NOTICE OF DECISION

WATER POLLUTION CONTROL PERMIT NUMBER NEV0088022

Newmont Mining Corporation Hollister Mine

HOLLISTER WEST PIT

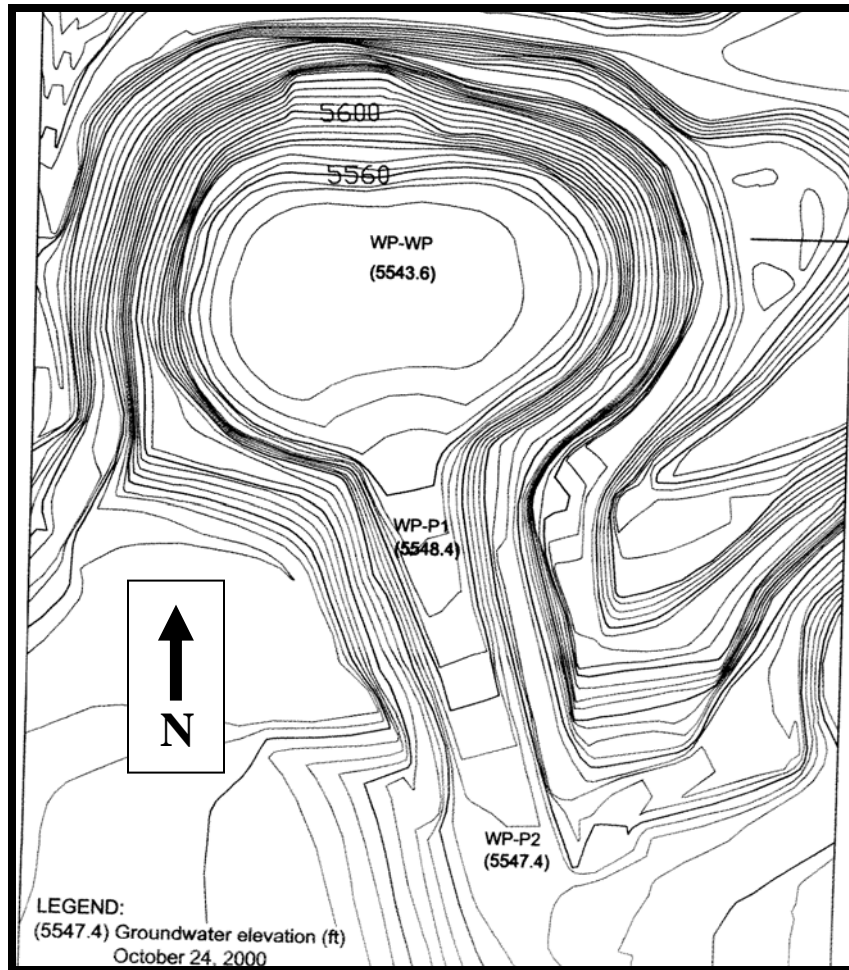
"The 2006 annual report indicates the water quality in the West Pit is an "item of concern" (2005-2006 Hollister Closure Site Operations Summary). If there is flow through the pit, there is clearly a potential to degrade downgradient waters of the state. It is possible that throughflow is currently degrading Little Antelope Creek (see the discussion below). If there is flow through the pit, there is clearly a potential to degrade downgradient waters of the state. It is possible that throughflow is currently degrading Little Antelope Creek...The Fact Sheet implies that the pit is a sink due to evaporation from the free water surface (Fact Sheet, page 2), however this has not been satisfactorily confirmed with data. Three piezometers have been installed "to confirm a terminal sink scenario" (*Id.*). According to the 2000-2001 Hollister Closure Site Operations Summary, there were piezometers placed in the pit in October 2000. Unfortunately the piezometer data is not included in the annual or quarterly reports which I obtained for this review, therefore the conclusion that the piezometers have demonstrated "ground water capture" can not be confirmed (*Id.*). As part of the response to this comment letter, I request that a table of piezometer data and a map of their locations be provided so that the conclusion can be independently verified"

As provided in the Fact Sheet (page 2): "One piezometer has been installed into the saturated zone (static groundwater table) within the pit backfill. Two piezometers, adjacent to and down gradient (ground water flow) of the pit have also been installed. These piezometers are used to determine the ground water gradient (flow direction) over time."

Piezometer WP-WP is a 2-inch diameter piezometer installed into the surface of the West Pit backfill material. Piezometer WP-P1 is a 6-inch diameter piezometer located within the pit area on the south haul ramp, some 90 feet south of the backfill material. Piezometer WP-P2 is another 6-inch diameter piezometer located on the south haul ramp approximately 580 feet south of the pit backfill material. The general groundwater gradient is south. Piezometers WP-P1 and WP-P2 are hydrologically downgradient of the West Pit lake. Little Antelope Creek is located approximately 2,850 feet SSE of the center of the West Pit backfill (WP-WP). As requested, below is a map showing the location of the three piezometers.

The two downgradient piezometers have always recorded a higher groundwater elevation than the backfill groundwater or pit lake surface water elevations as provided by WP-WP. This information would indicate that the direction of groundwater flow is to the north, back into the pit, rather than southeast and towards Little Antelope Creek.

Although the piezometer data indicates a terminal sink scenario, it is not possible to state conclusively that the West Pit does not have a flow through component in the direction of Little Antelope Creek. Both NDEP and the operator recognize this possible situation and the requirement for further action. This possibility is also alluded to in the Fact Sheet (page 7): "Beginning in 2003, an increase in TDS, as sulfate, was observed within Little Antelope Creek at monitoring site HOL-SSB (location just downgradient of the SOS bioreactor wetlands). This increase is most pronounced during low flow conditions (summer/fall). TDS values have been recorded as elevated as 2,800 mg/l, well above that characteristic of natural conditions.

At this time, it would appear that the Hollister Mine is responsible for this increase in TDS. The obvious source of sulfate would be the SOS. However, other potential sources should not be overlooked." [Emphasis added]. As such, this renewed Water Pollution Control (WPC) Permit requires (Schedule Of Compliance item) the operator to investigate definitively the source(s) of sulfate being introduced into Little Antelope Creek and to provide potential remedies if required. The operator shall submit a draft report for review providing their direction no later than 15 February, 2007. A NDEP acceptable final version will be required no later than 1 May 2007, with field activities to begin no later than late spring of 2007.

The NDEP will require, as part of the investigation, that the potential for a West Pit lake flow through component be investigated.
